DCR PHOENIX HOMES

CHESAPEAKE (508) Left
KITCHEN
MOUNTING HT: 84

CHESAPEAKE (508) - LEFT
ALT 4 BDRM / 2ND ENSUITE
VANITIES

BUFFET WALL ELEVATION
CHESAPEAKE (508) LEFT

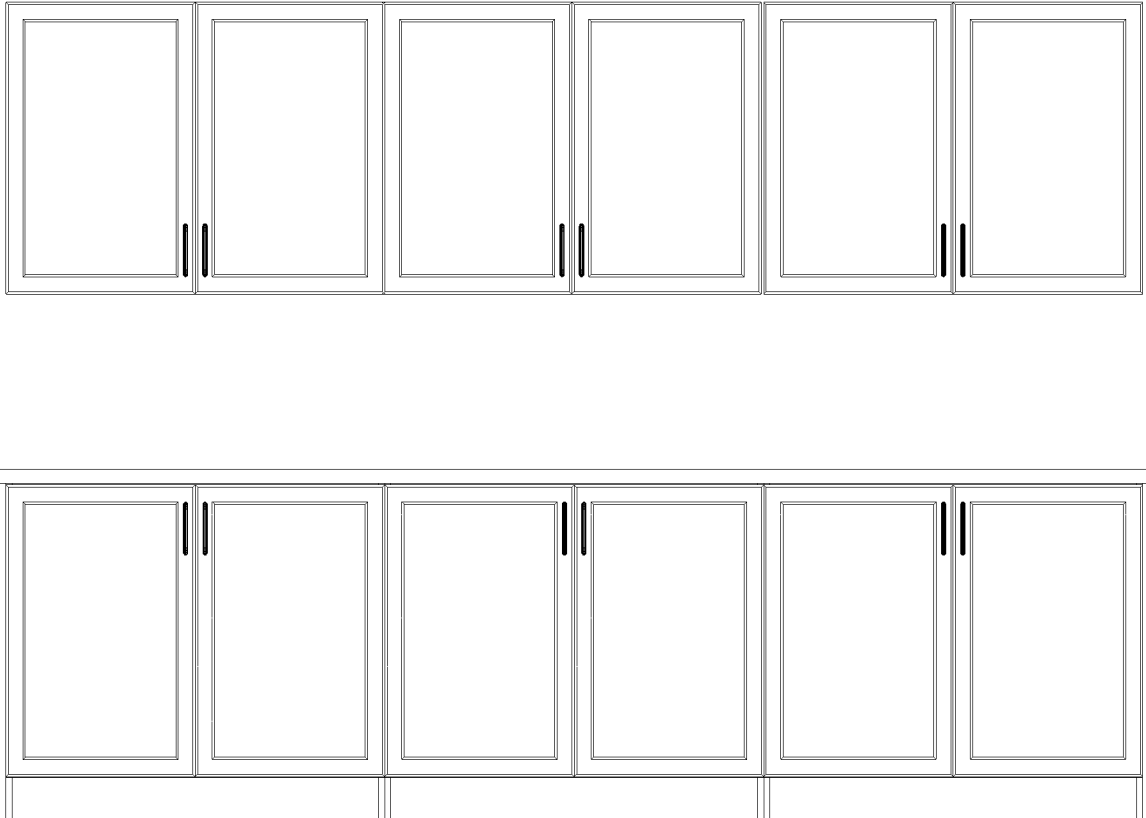
Increase height of uppers to reach 96" (42"h uppers installed at 18" above counter)

POWDER

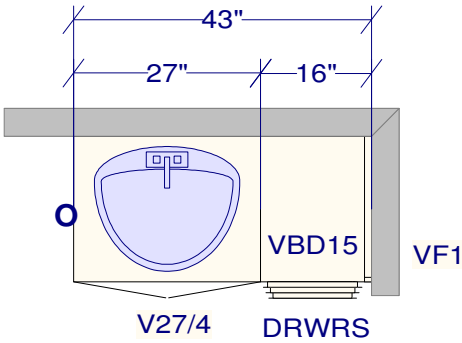
Increase vanity height to 36" H

MAIN BATH

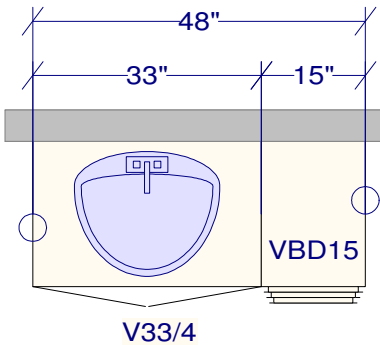
Increase vanity height to 36" H

2ND ENSUITE

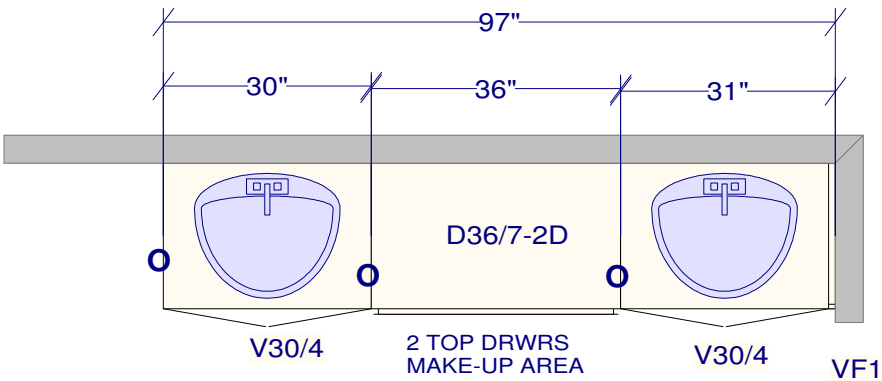
Increase vanity height to 36" H
